UNITED STATES PATENT AND TRADEMARK OFFICE

APPLICATION NO.	FILING DATE	FIRST NAMED INVENTOR	ATTORNEY DOCKET NO.	CONFIRMATION NO.
10/055,582	01/23/2002	Dennis P. Silver	11899	7015

Office Action Summary

DETAILED ACTION***Drawings***

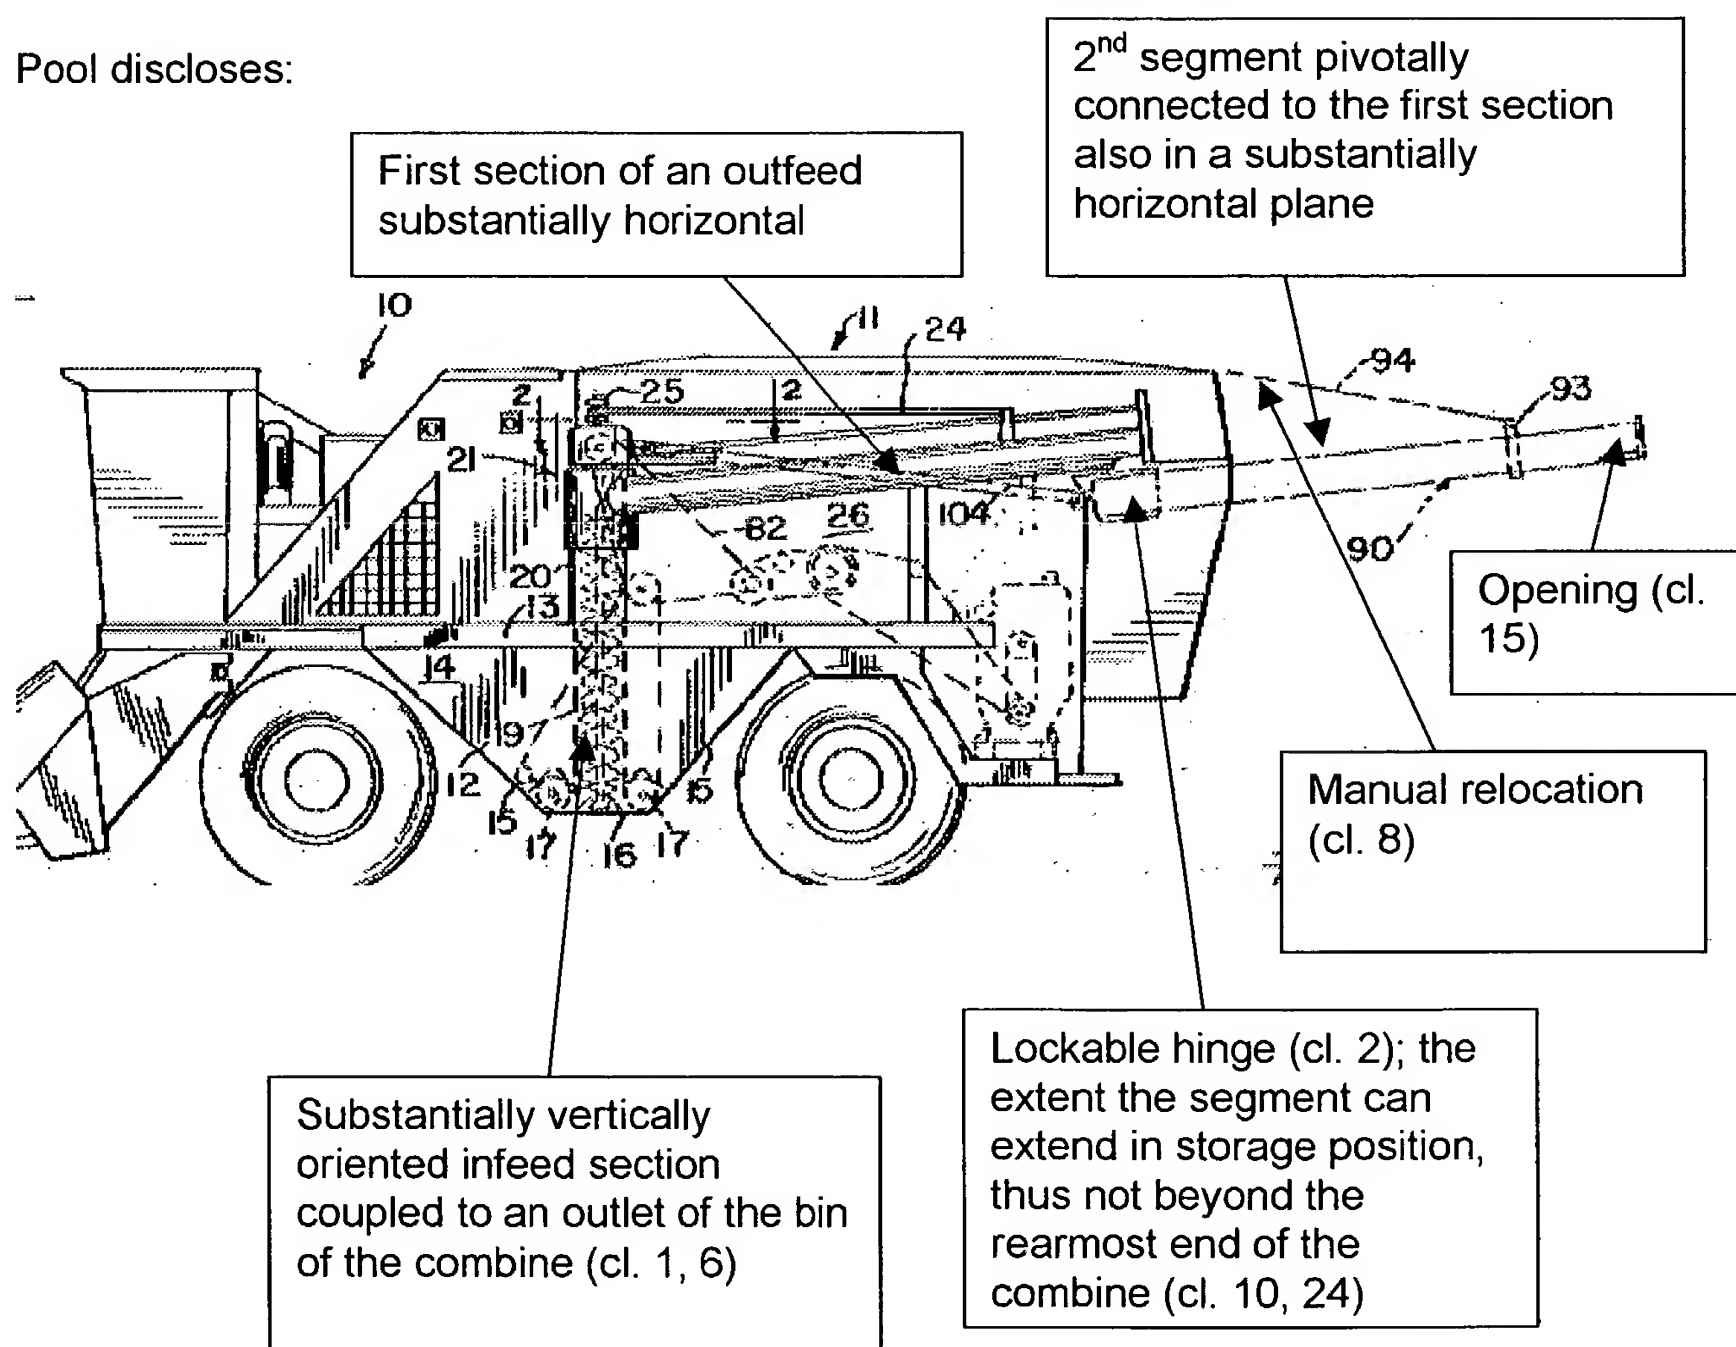
It is noted that in the original disclosure and in the drawings a hydraulic actuator was not shown. It is further noted that the concept of using a hydraulic actuator to move

to pieces relative to each other is well known. However, the Applicant has not shown in the drawings and in the disclosure how a newly proposed actuator would be novel in view of the state of art. Reviewing the disclosure, it is clear that Applicant's invention pertains to the auger sections. It is nowhere found that a hydraulic actuator would be novel to use and would solve any certain problems or would improve on the state of the art device.

Accordingly, the hydraulic actuator appears to be, subsequent to an Examiner's objection, an after thought addition to the drawings in order to overcome either the objection's to the drawings or an attempt to differentiate from those augers which do not use or require a hydraulic actuator.

Finally, the operation of the actuator by stating that "can be remotely actuated" (it is noted that "via remote operator" was a new matter addition to the disclosure) is not sufficiently disclosing how it actually works.

Therefore, the rejection is based on the original concept the Applicant believes is an improvement, which directly deals with the foldable auger sections.

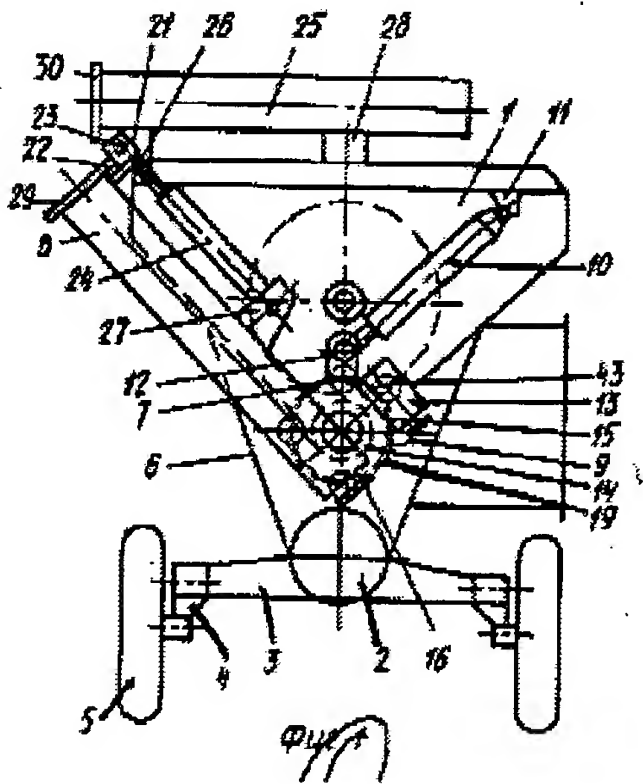
In re claims 4, 17-18, in storage position the flyers do not operate thus it is prevented to accidentally release through the open end any grain;

In re claims 5, 13, 23, 26-27, 31, in storage position both segments are parallel to the longitudinal axis of the combine;

Pool does not disclose a coaxial pivoted hinge connection between the first & the second segments.

Barinov as shown below and disclosed in the abstract hingedly & pivotally connecting a second segment for giving wider range of use of the discharge auger system.
